# 1992 Corvette ZR-1: Service Bulletin: Lack of Wide Open Throttle Engine Underpower

**Subject:** LACK OF WOT-LOW ENGINE POWER REVISED CABLE ADJUSTMENT PROC.

**Model and Year:** 1992 CORVETTE ZR-1 WITH 5.7L ENGINE AND MANUAL TRANSMISSION

**Bulletin Number:** 92-214A-7B - (07/01/1992)

Cable Adjustment Mechanism

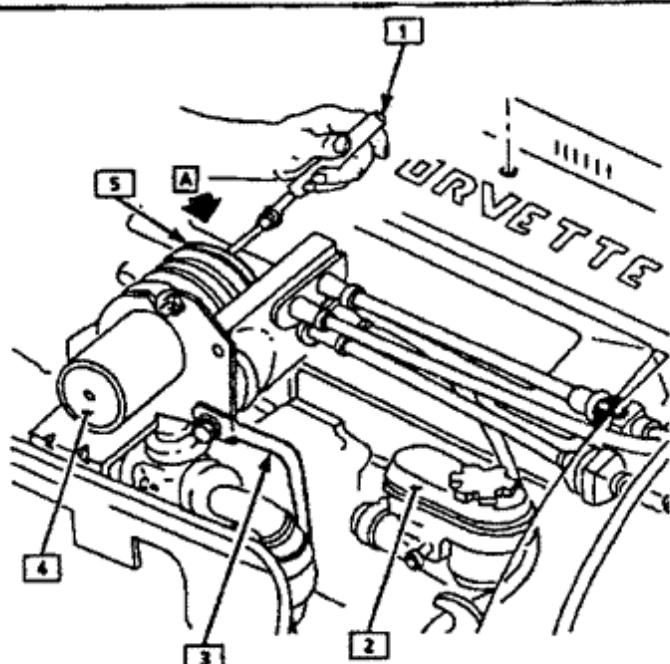
1. Remove adjuster cam assembly splash cover, foam shield, and cable cam cover.
2. Disconnect cruise control cable from the cruise control servo.
3. Depress reset button on the throttle control cable and fully extend cable sheaths (see figure).
4. Insert a 1/8 inch drill bit into adjuster assembly alignment hole (see figure, item A).

\* ALWAYS MAKE SURE CABLE SHEATHS ARE AT THEIR FULLY EXTENDED POSITION BEFORE PERFORMING ADJUSTMENT PROCEDURE

Adjusting Throttle Cable

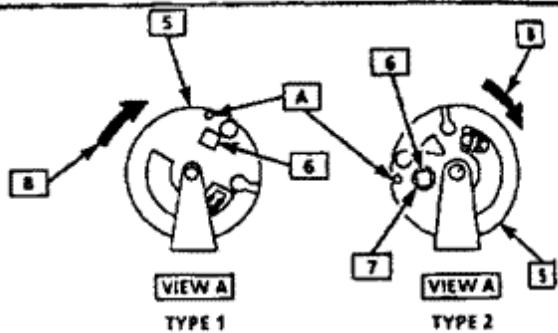
5. Insert a torque wrench with a 1/4 inch drive extension into square hole on the cruise control cam (type 1) or through the cruise control cam into the accelerator cam (type 2) (see figure, item 6).
6. Turn the torque wrench clockwise until obtaining a torque of 4 N.m (35 lbs. in.). During adjustment, several clicks of the adjuster should be heard. If not, repeat step 3.
